<b>Docket Number:</b>	21-AFC-02
<b>Project Title:</b>	Willow Rock Energy Storage Center
<b>TN #:</b>	259675
<b>Document Title:</b>	Willow Rock Data Request Set 3 Response
<b>Description:</b>	N/A
<b>Filer:</b>	Kathryn Stevens
<b>Organization:</b>	WSP USA Inc.
<b>Submitter Role:</b>	Applicant Consultant
<b>Submission Date:</b>	10/23/2024 4:55:23 PM
<b>Docketed Date:</b>	10/23/2024

**Willow Rock Energy Storage Center (21-AFC-02)**  
*Data Request Response Set 3*

**GEM A-CAES LLC**

PATH: G:\Hydro\Aerial\09\_PROJECTS\US029687\_4225\_GEM\_A-CAES\_DISCOVER\110\_DATA\_ADEQUACY\02\_PRODUCTION\A\02FIGURES\CEC\_DataRequest\_3\FigGen\_Hydro\Aerial\_FigGen\_CEC\_DR\_3.aprx PRINTED: 10/23/2024 at 1:35 PM BY: USKO127009

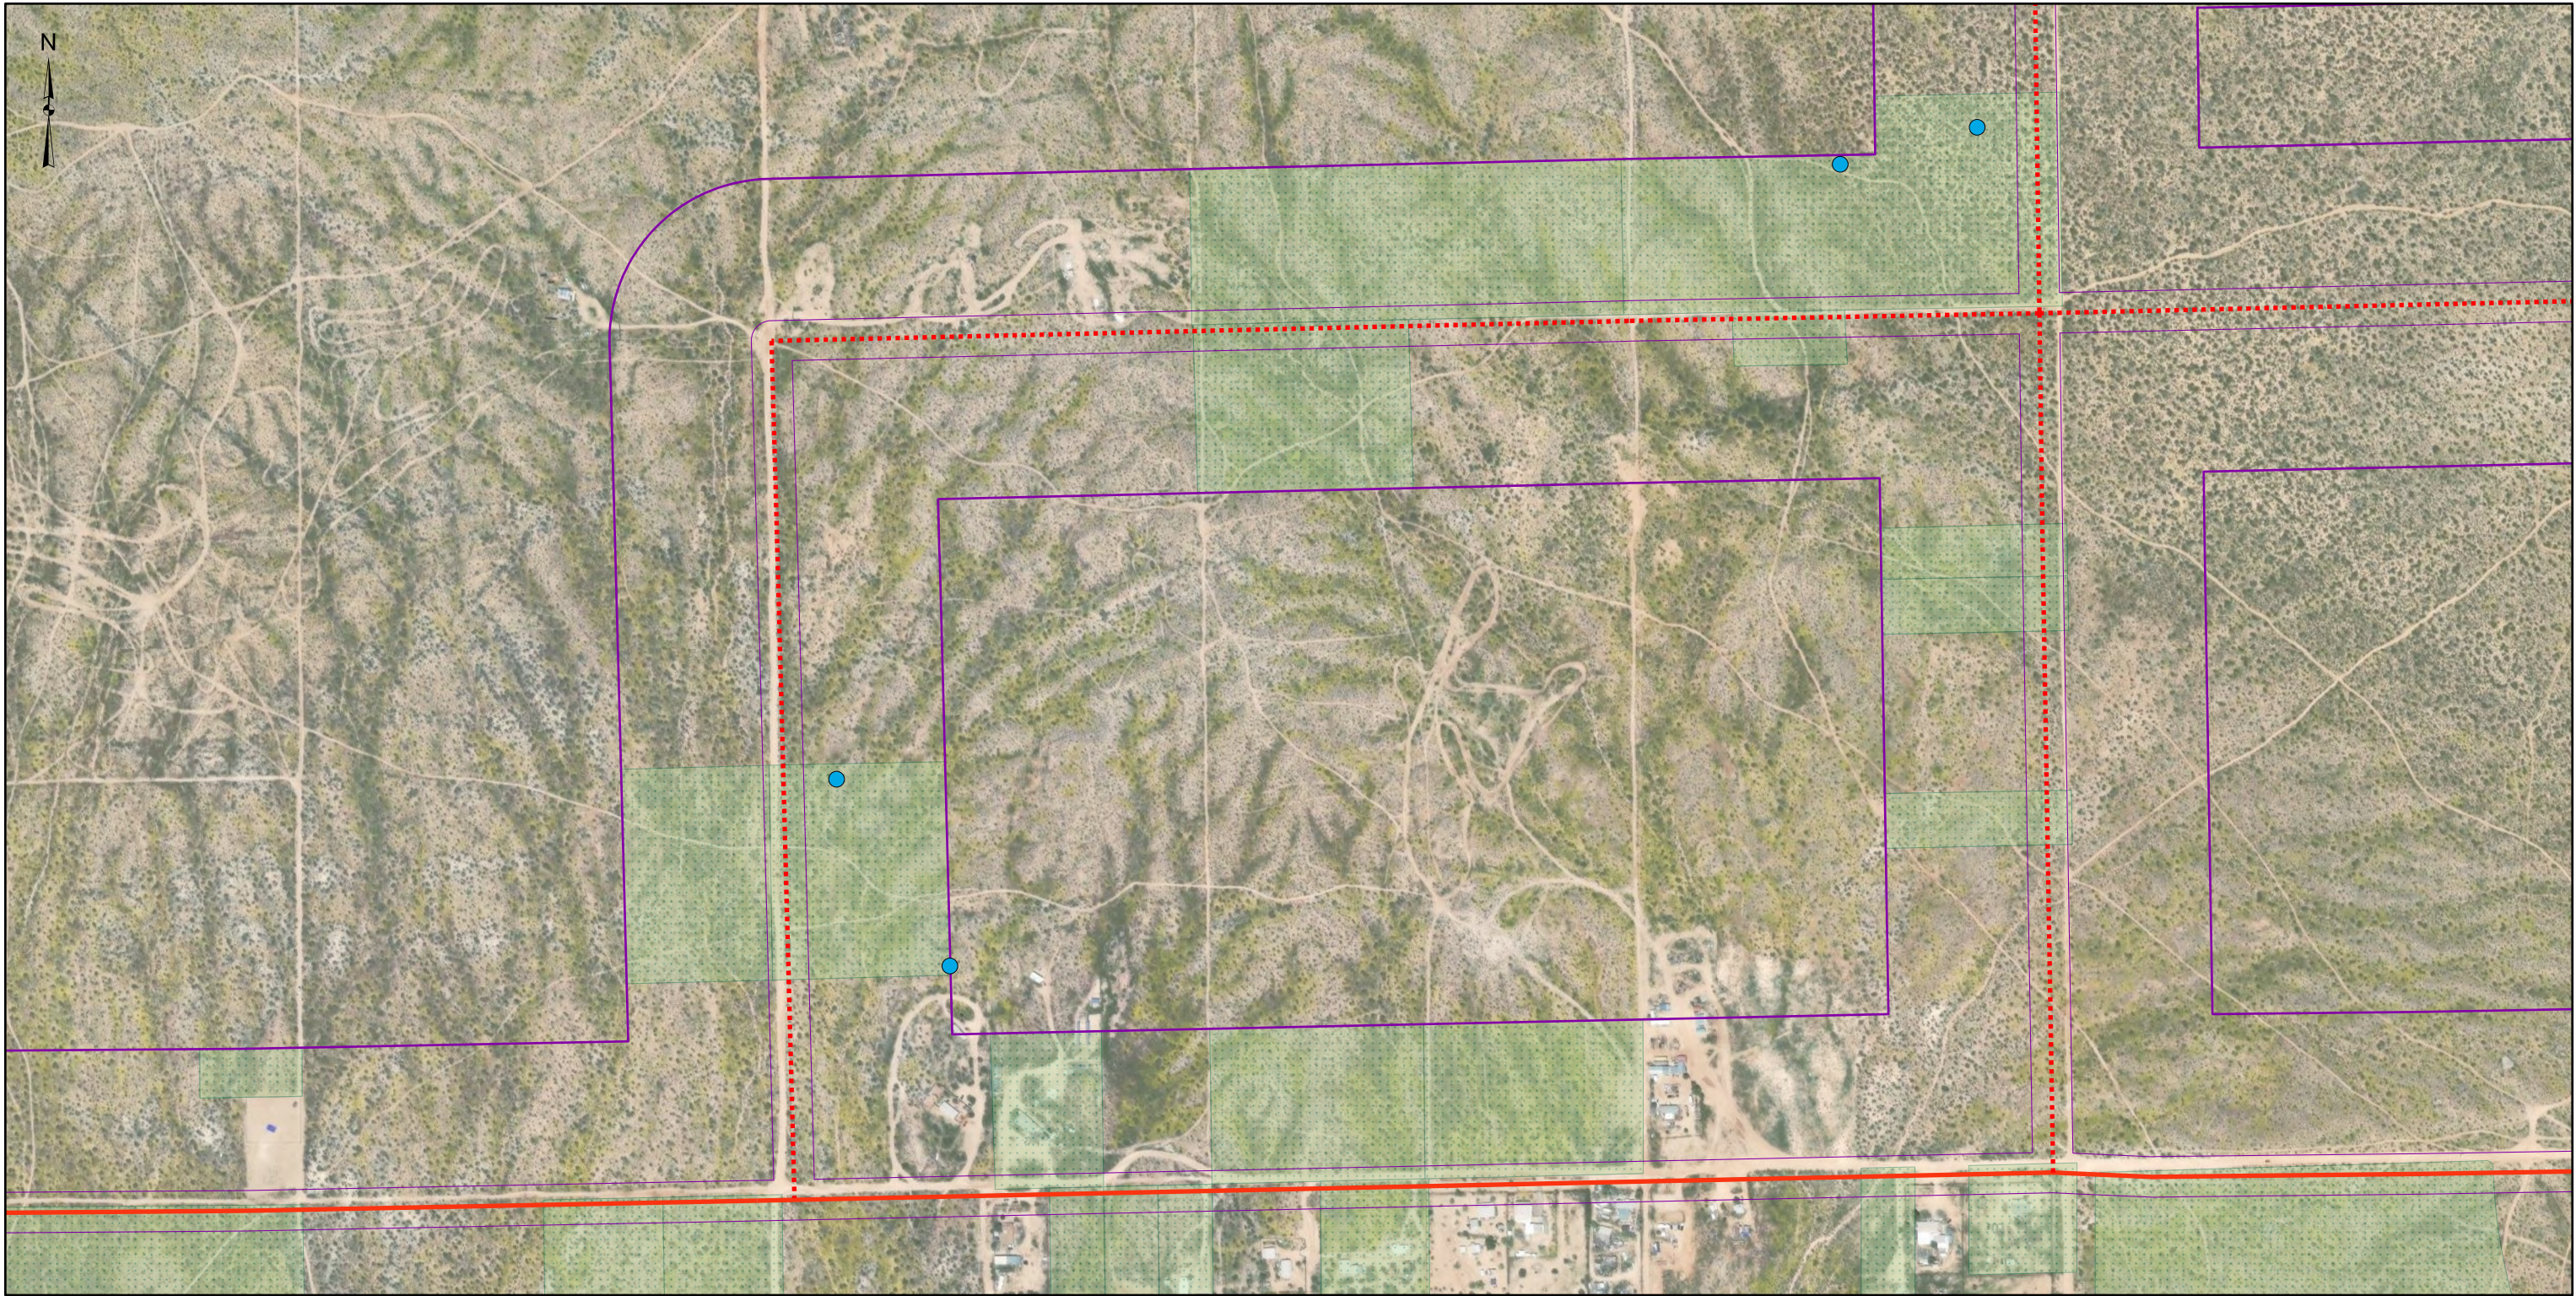
**DR44:** Please provide a map of the location(s) of silver cholla found within all areas of the project (e.g., project site, gen-tie, staging, parking, etc.) including (to the extent feasible) within a 500-foot buffer from the areas that will be impacted by the project.

**Response:** See **Attachment DR44-1** for a map of the locations of silver cholla observations found in all areas of the project within a 500-foot buffer.

Figure DR69B-1: Process Flow Chart

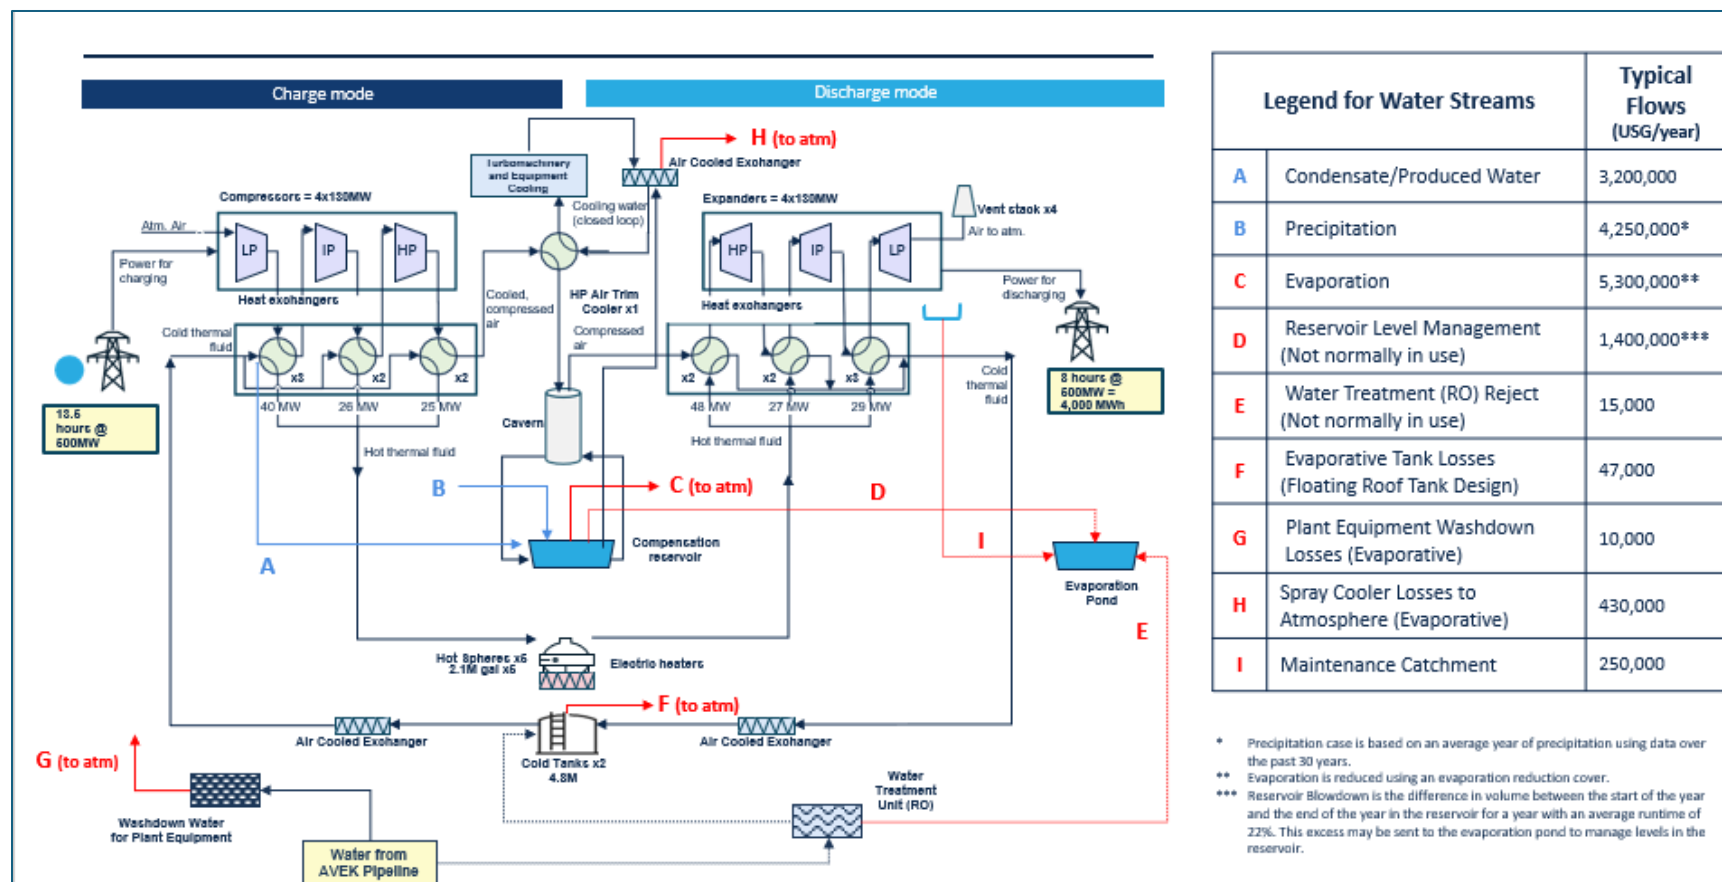
**Lahontan RWQCB 69-B.** *The Supplemental Application discusses a water balance that includes additions and losses measured against the capacity of a hydrostatically compensating reservoir. Most of these losses are not shown in the process flow diagram associated with the power generation flow diagram. We request the Applicant provide a process flow diagram that consolidates the water balance and the power generation components, this would yield a more complete understanding of how the water balance correlates with the hydrostatically compensating reservoir included as a component to produce power. This information is necessary to determine whether we would request the Applicant to submit a Report of Waste Discharge.*

**Response:** Attachment DR69B-1, Figure DR69B-1 presents a simplified process flow chart that consolidates the water black and the power generation components.

**Figure DR69B-1** depicts the water movement related to the thermal charge and discharge modes of the system during operation. The charge mode cycle takes 13.5 hours to complete and the discharge mode cycle takes 8 hours to complete. Process water is managed via three primary closed loops: 1) cavern/compensation reservoir; 2) thermal management system; and 3) cooling water system. For the cavern/compensation reservoir, water is either in the cavern or compensation reservoir once the charge or discharge process is complete. For the thermal management system, water is either in the electric heater spheres or cold-water tanks once the charge or discharge process is complete. The cooling water system loop has the least amount of water of the three and provides auxiliary cooling capacity to the thermal management system during extreme ambient temperature days. The cooling mechanisms used in the thermal management system and cooling water system are the same and consist of air-cooled heat exchangers. No cooling towers are used in any part of the process.

In **Figure DR69B-1**, the water streams in blue are additions and the water streams in red are subtractions to the overall system. The legend summarizes the estimated yearly amounts of each water stream based on an average precipitation year and assumed operating condition. The water balance is anticipated to be net zero for a normal precipitation year under the assumed operating condition. The retractable cover on the compensation reservoir allows for flexibility in the evaporation rate to provide a means to control water levels within the compensation reservoir. The water discharge from the system consist of evaporative and liquid. The evaporative losses are used to extinction and are designated as “to atm” in **Figure DR69B-1**. The potential liquid discharges will be sent to the evaporation pond and are water treatment reject water from Reverse Osmosis (stream E), maintenance water (stream I), and excess compensation reservoir water (stream D). See Response 69-G for more details on the anticipated water quality. The annual averages have been updated since the Supplemental AFC because of advances in the engineering design.

**Figure DR69H-1: Blind Bored Shaft Profile**

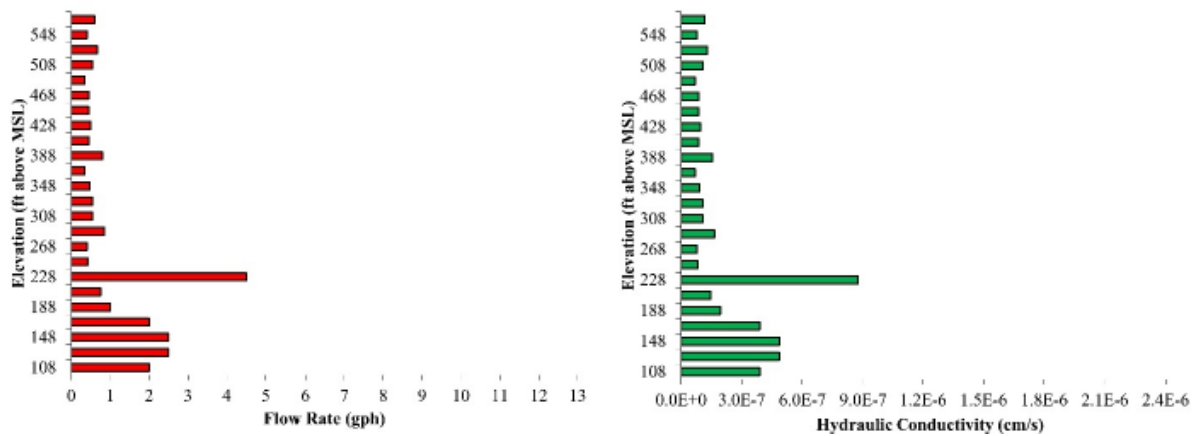
**DR78:** Please provide the basis for determining that 100-ft between the ground surface and the top of the cavern is sufficient and safe to support the cavern ceiling given the soils type at the site.

The roof of the cavern will be approximately 2,050 feet bgs (Refer to **Figure DR69H-1**), meaning that at least 1,950 feet thick massive Quartz Monzonite rock mass will exist between the cavern roof and the bottom of soils zone at the site. Numerous specimens obtained from multiple deep exploration boreholes across the project site indicate that the Quartz Monzonite has an average Uniaxial Compressive Strength greater than 16,000-psi. Preliminary geotechnical stability analysis has indicated that the proposed underground cavern space (40 feet width x 50 feet height) will have long term stability over 50-years of design life, in conjunction with the designed
